**TOWN OF WINTER PARK  
PLANNING COMMISSION  
Tuesday, September 28, 2021 8:00 AM  
Online and In-Person Meeting**

**TO** Planning Commission  
**FROM** Hugh Bell, Planner  
**THROUGH** James Shockey, Community Development Director  
**DATE** September 28, 2021  
**RE** Design Review – Block 1, Lot 3, Hideaway Pines Subdivision – 123 Pine Cone Lane

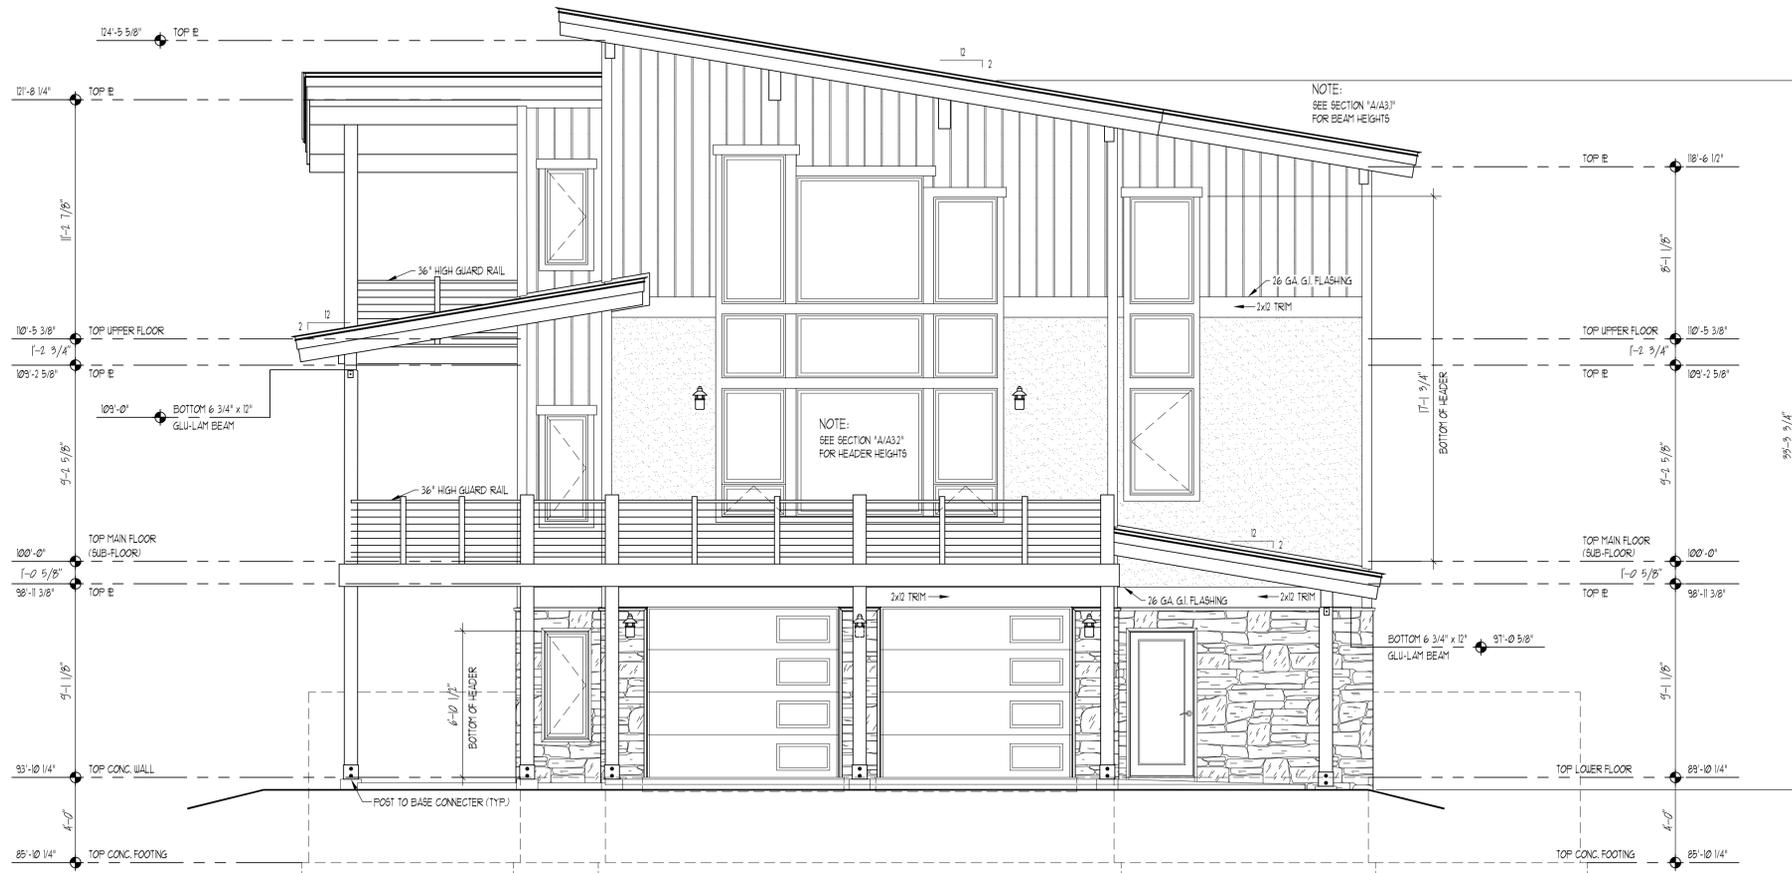
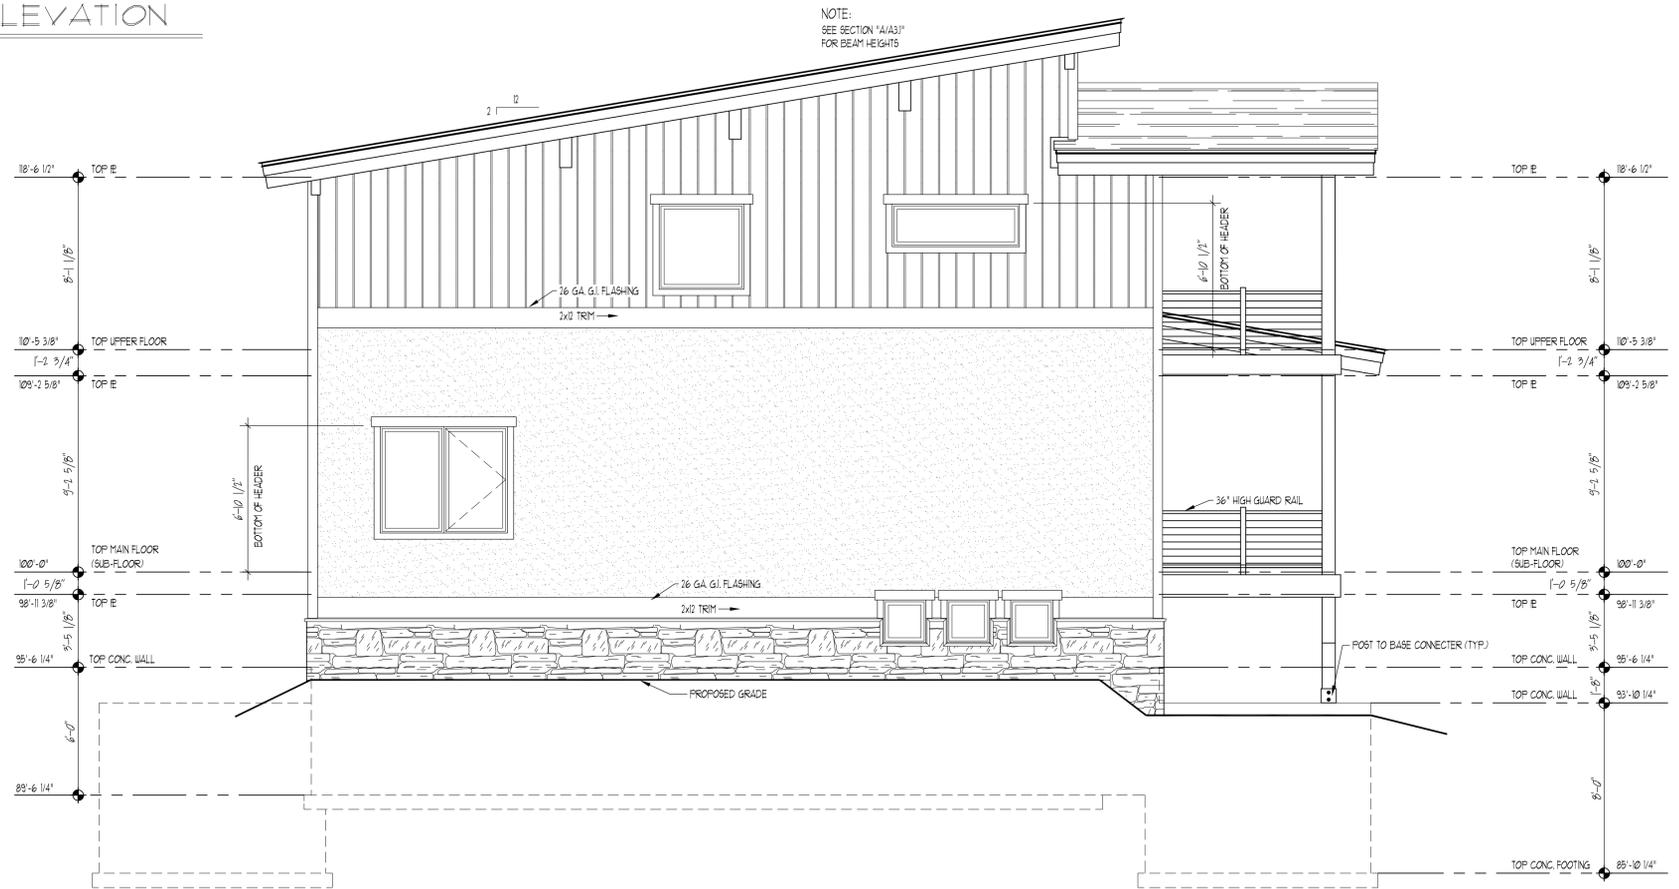
Satisfactory. Maximum midpoint height is ~33'-11" and maximum overall height is ~36'-9". Maximum permitted midpoint building height is 35' for R-1.

SITE PLAN/ LANDSCAPE PLAN  
1" = 10'-0"

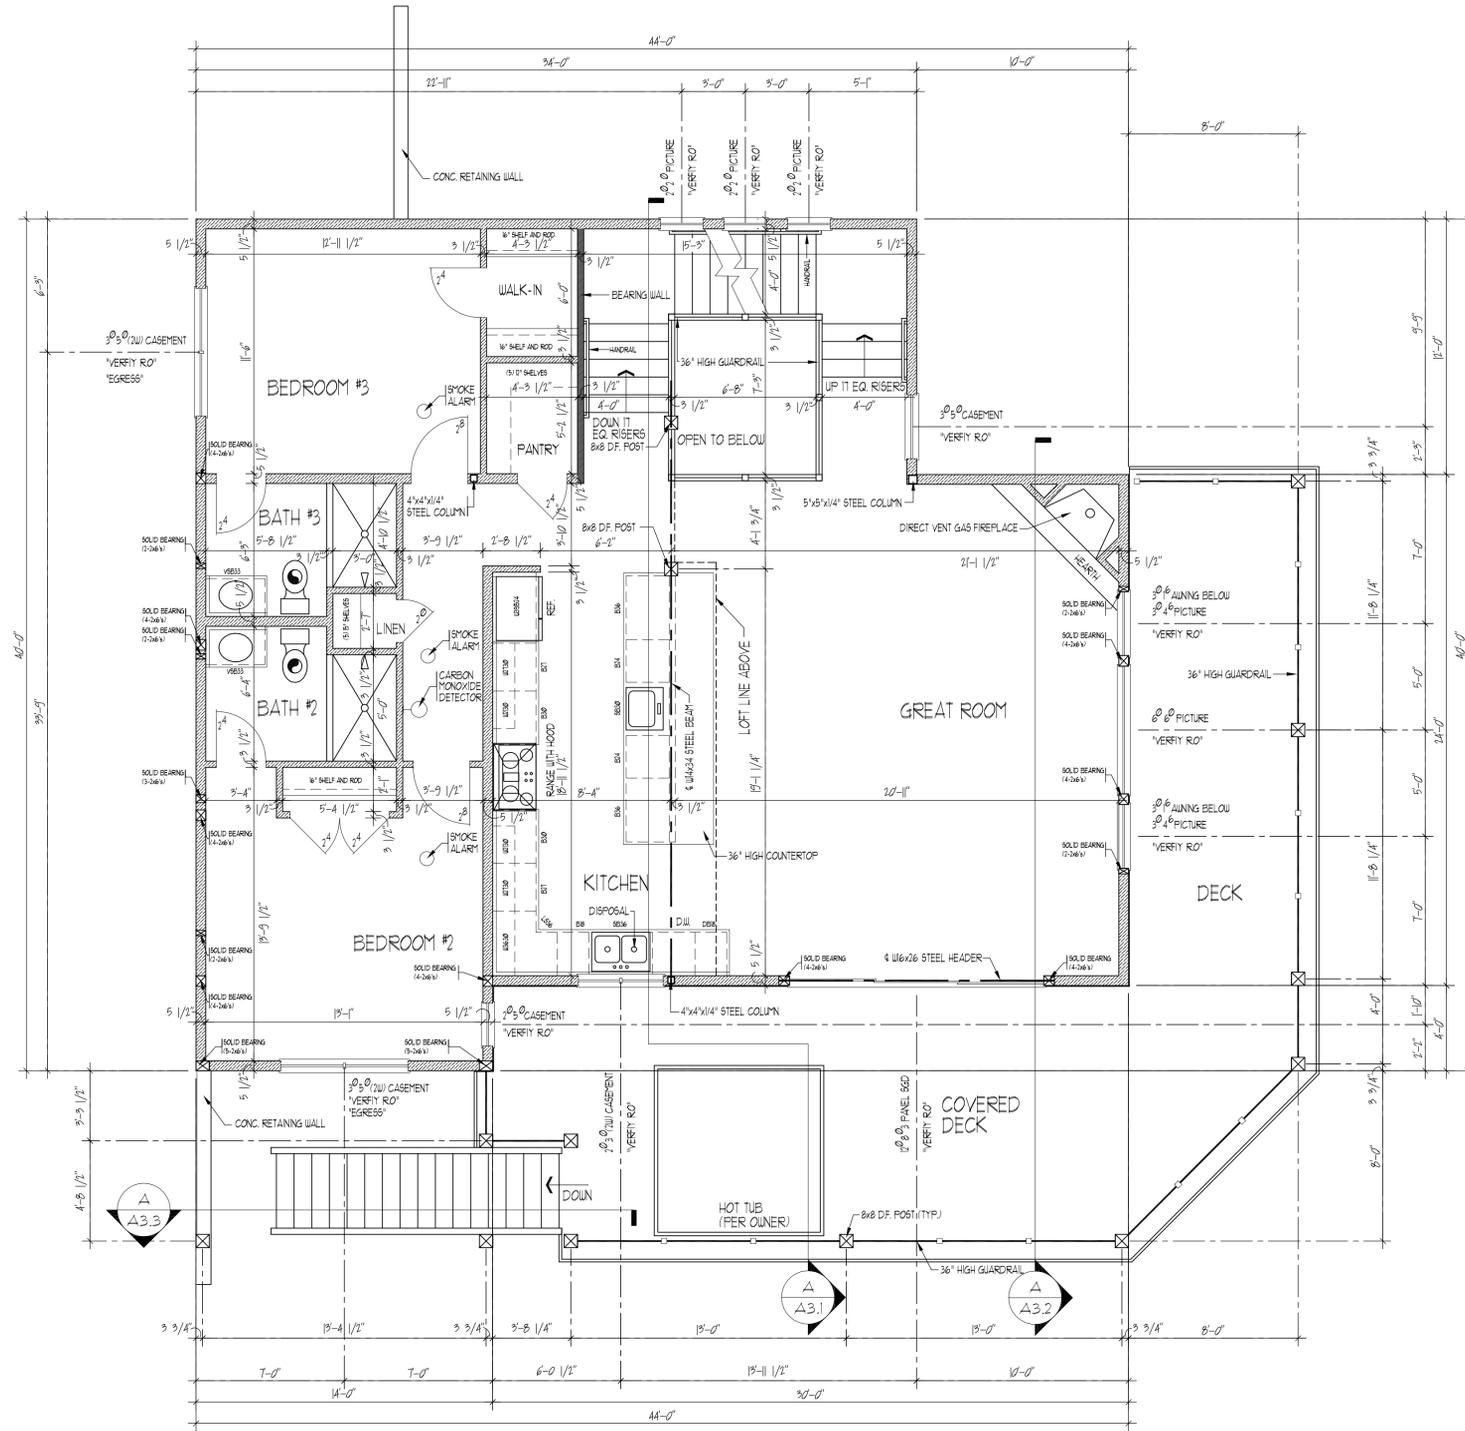
Satisfactory. Since this lot is zoned R-1, setbacks are as follows: 25' front yard; 20' rear yard; and 10' side yard.

Satisfactory. Proposed building coverage is ~39.3%. Building coverage is limited to 40% in the R-1 zone district.

Satisfactory. Two garage spaces and two driveway spaces are provided.

Satisfactory. LTZs are not required for the R-1 zone district. Snow storage does not encroach into landscaping.

Satisfactory. 478 sq. ft. are required and 574 sq. ft. are provided. 3.11 of the Standards requires that a minimum of 25% of all driving surfaces (including gravel shoulders), parking areas, and pedestrian walkways is provided as snow storage.

Satisfactory. Maximum driveway slope is 5%.

MAIN FLOOR EXTERIOR LIGHTING PLAN MAIN FLOOR = 1472 SQ. FT.  
 SCALE: 1/4" = 1'-0"

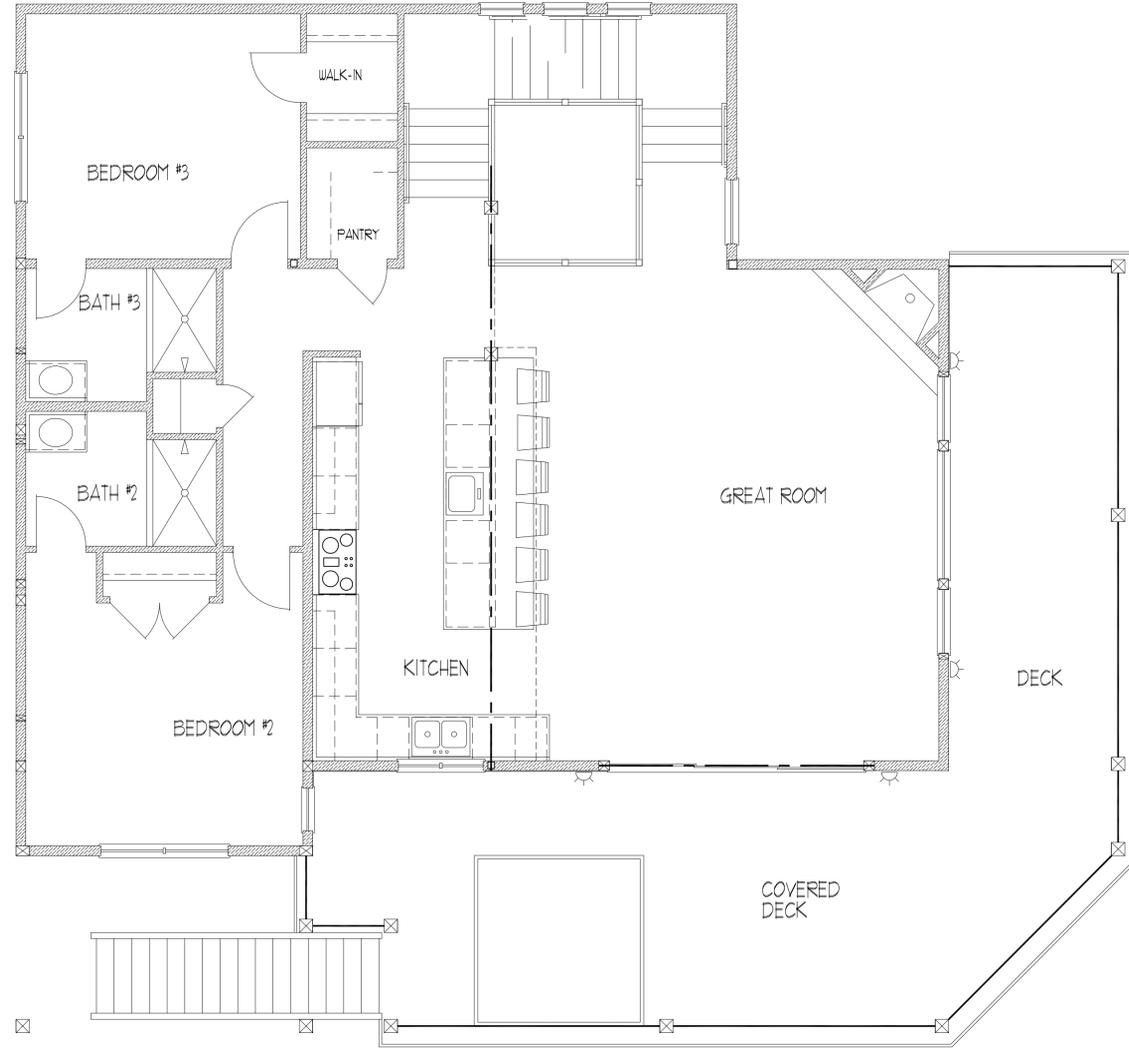
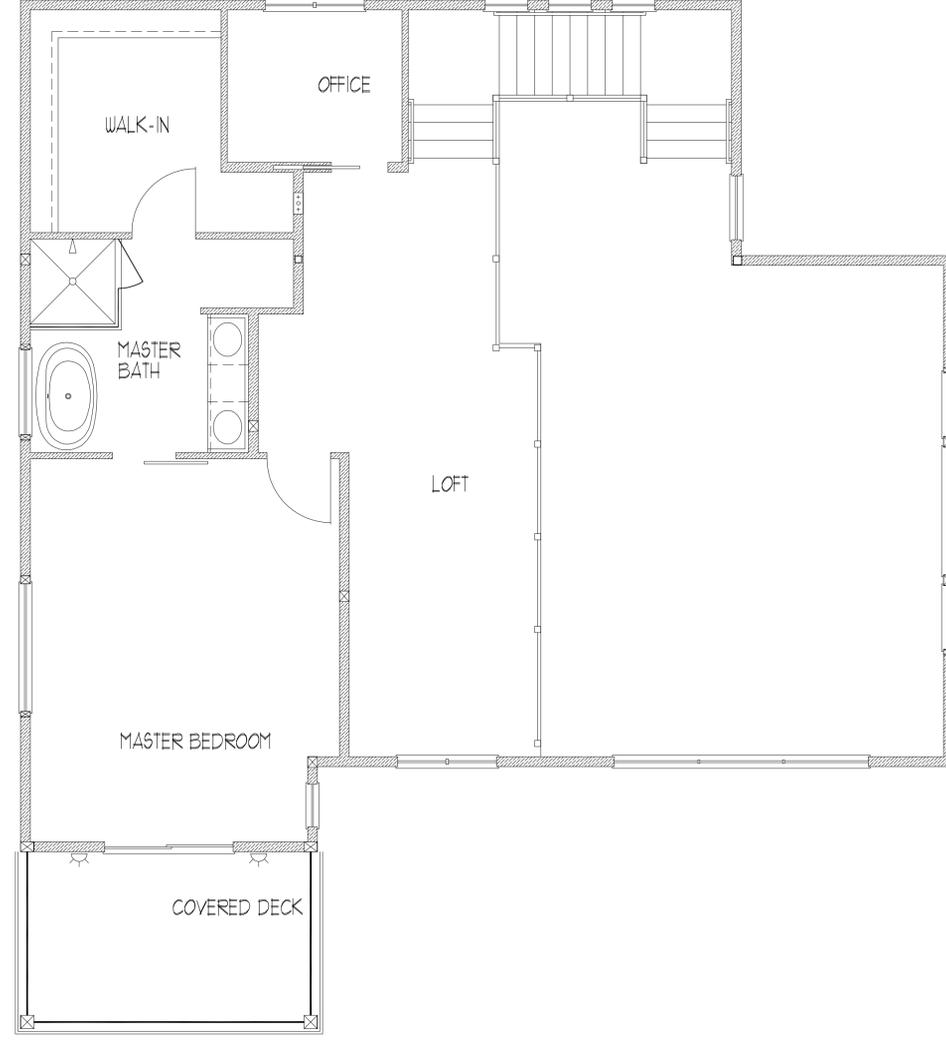
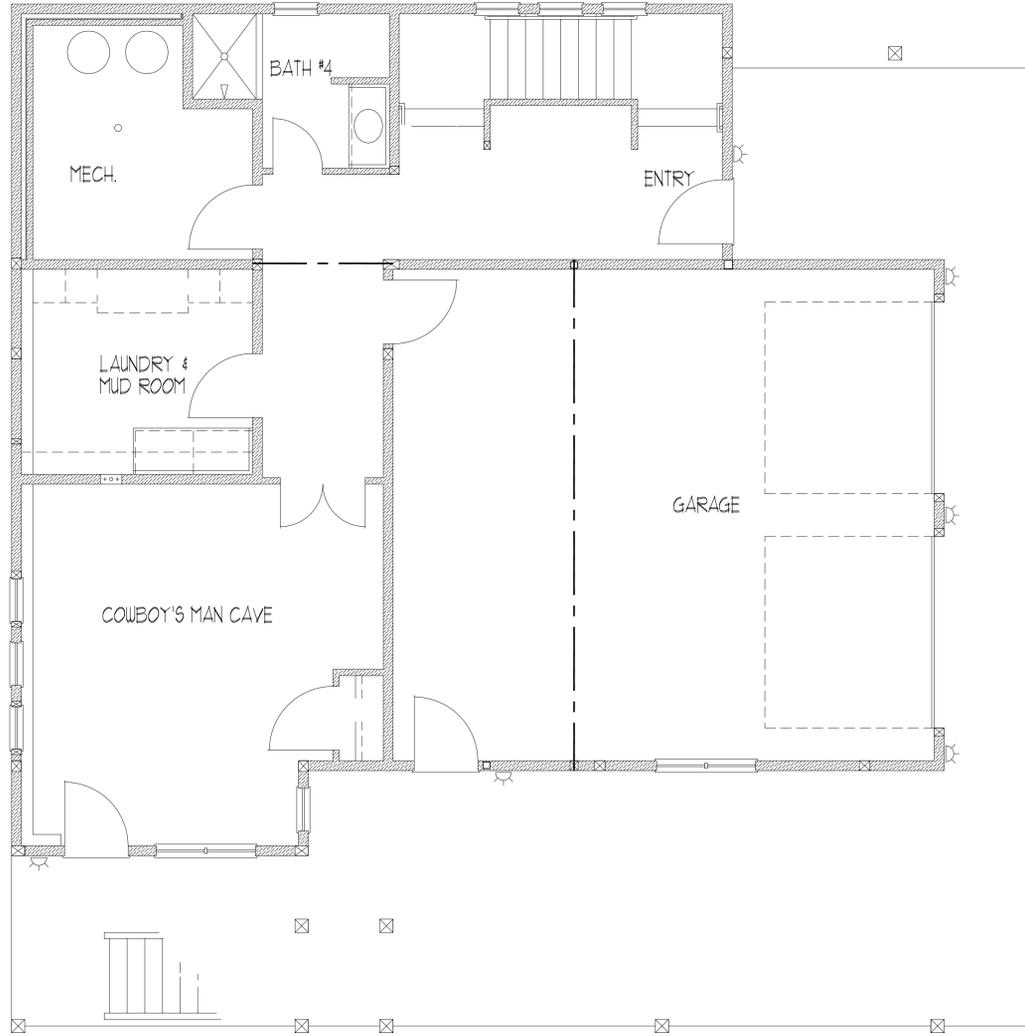
**Exterior Lighting:**  
Satisfactory. One exterior luminaire is proposed. Per the Residential Design Guidelines, luminaires shall be task-oriented areas. Photometric plans are not required for single-family homes.
